Our Ref: S25-243

**Attention:** Luke Hadrick  
**Application Reference:** A006957882  
**Application Type:** Subdivision and Reconfiguration of a lot for a 1 into 2

**RE: RESPONSE TO BCC FURTHER ADVICE ASSOCIATED WITH THE PROPOSED SUBDIVISION AND RECONFIGURATION OF A LOT LOCATED AT 77 MINIMINE ST, STAFFORD 4053.**

**TITLE**  
PRELIMINARY SERVICES PLAN

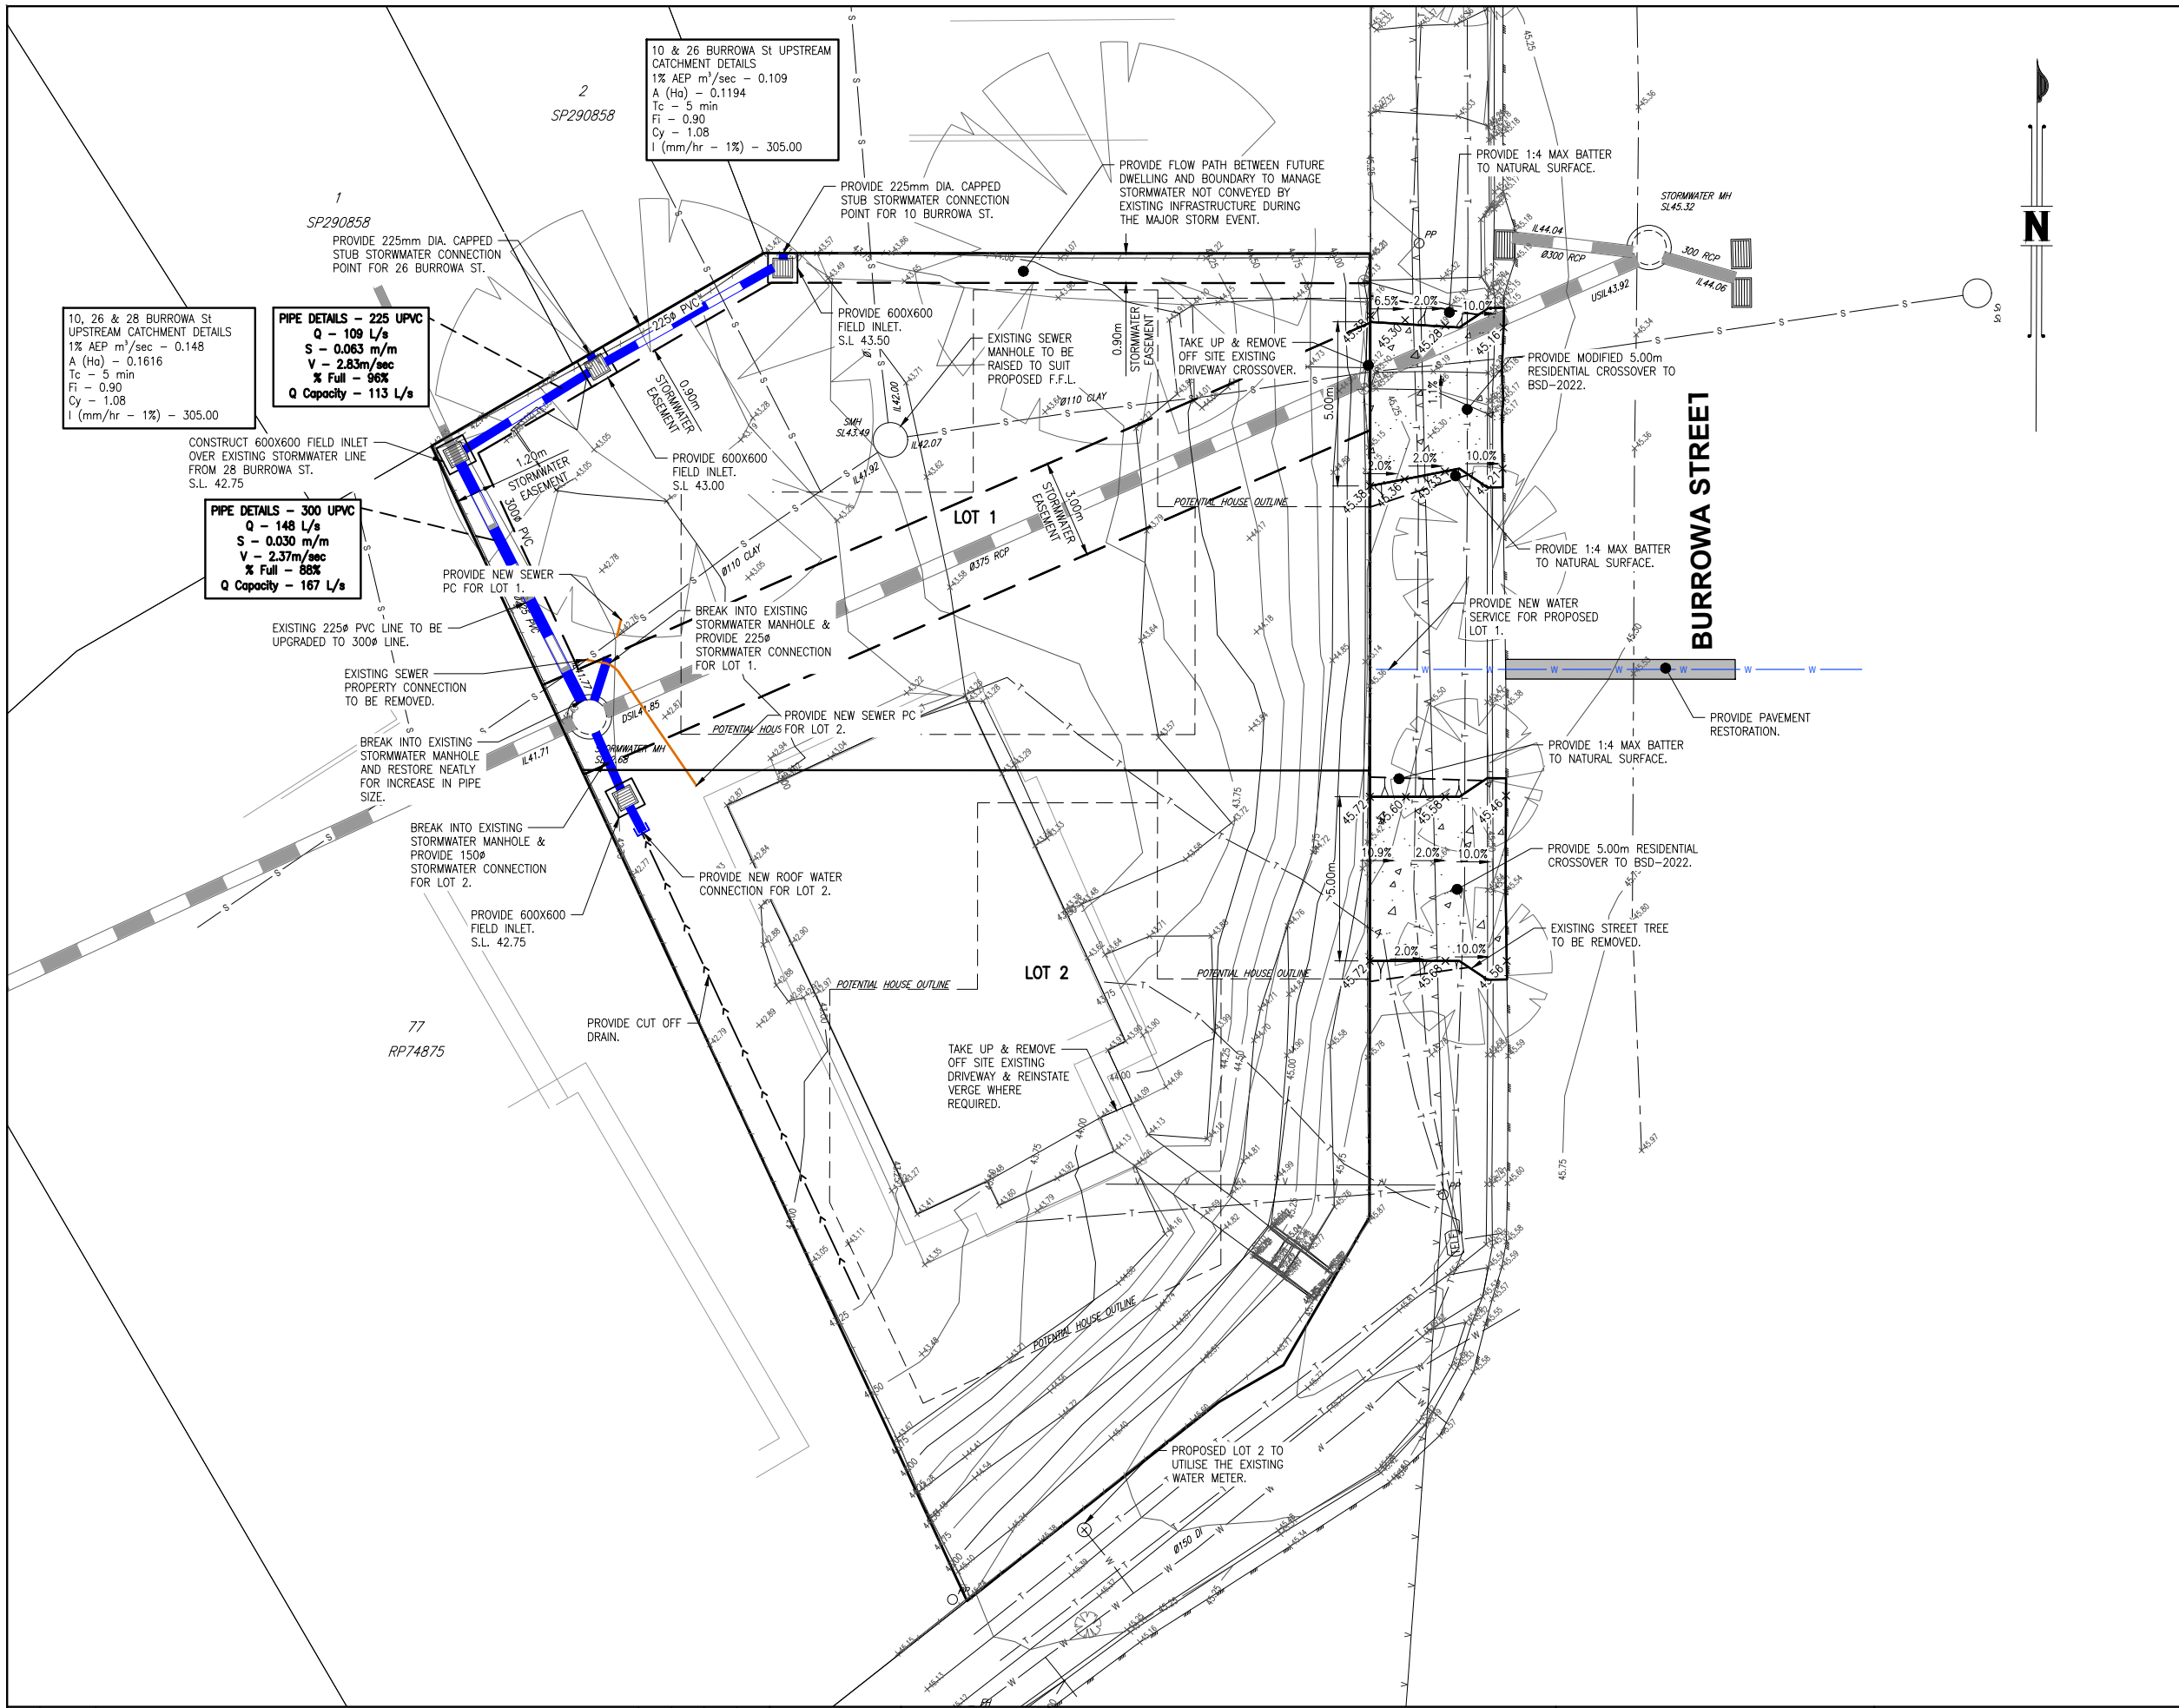
1. *It is acknowledged that a 3.0m easement for underground drainage has been reflected on the Preliminary Services plans; however, the Revised Subdivision Plan has not been updated accordingly. Additionally, an overland flow channel is proposed along the northern boundary to manage stormwater not conveyed within the underground infrastructure (i.e. during major storm events at the sag point on Burrowa Street). Details of the channel have not been provided on the drawings. In accordance with PO4/AO4.2 of the Subdivision code, and PO2/AO2.1 & AO2.2, PO3/AO3.2, AO3.3 & AO3.4, and PO11/AO11.1 of the Stormwater code:*

- a) *Provide amended drawings showing drainage easements. This should include:*
    - i. *A 3.0m wide easement for underground drainage centrally located over the 375mm diameter pipe traversing the site, in accordance with IDPSP – Chapter 7 Stormwater drainage; and*

- ii. *Details of the flow path of the proposed overland flow channel, including the provision of a 900mm wide easement.*

2. *Provisions are required to be made for the future orderly development of adjacent properties at 10, 26 and 28 Burrowa Street with respect to stormwater drainage. These properties are located upslope of the subject site, resulting in stormwater naturally flowing toward and through the site. Accordingly, stormwater infrastructure must be provided within the development to appropriately manage these flows. In accordance with PO4/AO4.2 of the Subdivision code, and PO2/AO2.1 & AO2.2, PO3/AO3.2, AO3.3 & AO3.4, and PO11/AO11.1 of the Stormwater code:*

- a) *Provide amended drawings showing a piped stormwater drainage connection for upslope properties. The drainage infrastructure is to extend to the boundary of the upslope lots to ensure that future connections can be made without requiring works within the subject site. The connection is to include the following:*

- i. *A minimum pipe size of 225mm nominal diameter, connected to a lawful point of discharge;*
    - ii. *Design of the upslope stormwater connection for fully developed catchment flows, in accordance with Section 7.6.5 of the IDPSP; and*

- iii. *A 900mm wide easement for underground drainage located over the stormwater pipe/connections servicing the upstream properties, in accordance with IDPSP – Chapter 7 Stormwater drainage.*

A 3.0m easement over the underground drainage has been updated on the Revised Subdivision Plan, and the flow path along the northern boundary is to be considered as a stormwater passage in the event of the existing infrastructure exceeding capacity, as opposed to an overland flow channel, as previously noted in the information request. The allocated space between the building and the boundary provides an adequate flow path when the existing stormwater infrastructure exceeds capacity and a proposed easement has been updated on the drawings, with details of this area to be finalised during the detailed design, as the current built form plans note this area as a footpath and provide sufficient width and depth in the event the capacity of the existing stormwater is exceeded.

A piped connection has been updated on the drawings, with this stormwater line to be located within an easement and extended to the boundary of the upslope lots, to ensure future connections can be made without entering the subject site.
